SUBJECT: INITIAL EXAMINATION REPORT NO. 50-188/OL-08-01, KANSAS STATE
UNIVERSITY TRIGA REACTOR

U. S. NUCLEAR REGULATORY COMMISSION
OPERATOR LICENSING INITIAL EXAMINATION REPORT

REPORT NO.: 50-188/OL-08-01
FACILITY DOCKET NO.: 50-188
FACILITY LICENSE NO.: R-88
FACILITY: Kansas State University TRIGA reactor
EXAMINATION DATES: January 15 – 22, 2008
SUBMITTED BY: IRA/ 2/12/08
Paul V. Doyle Jr., Chief Examiner Date

FACILITY COMMENTS ON WRITTEN EXAMINATION

QUESTION A.10 [2.0 points. 2 each]

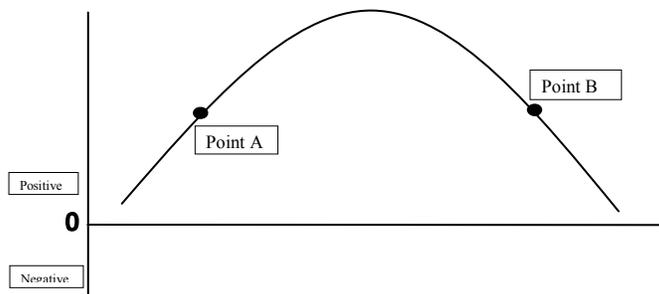
Could you describe or send me a sketch of the "integral rod worth curve" used in question 1? I'm not challenging the question, but am asking that you review one for future usage.
